STATE OF MAINE
 DEPARTMENT OF TRANSPORTATION
 16 STATE HOUSE STATION
 AUGUSTA, MAINE
 04333-0016

April 15, 2010
 Subject: **Kittery**
 Maine State Pin No: 015099.00
Amendment No. 2

Make the following changes to the Bid Documents:

CLIP DETAIL

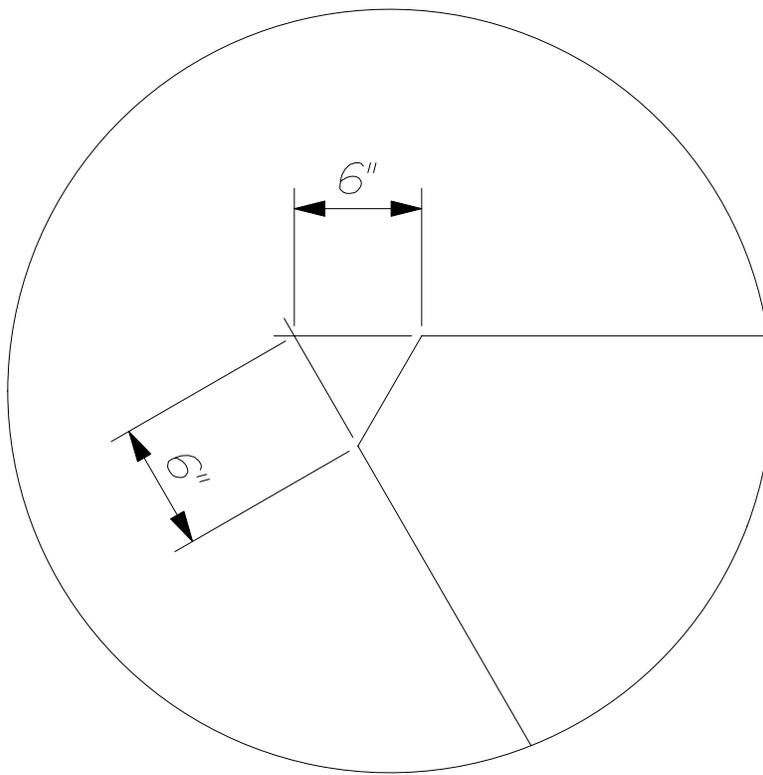
In the Plans, Sheet Number 35 of 40, **ADD** the attached “CLIP DETAIL” under the “NEXT BEAM SECTION” detail.

Adjust reinforcing steel to fit
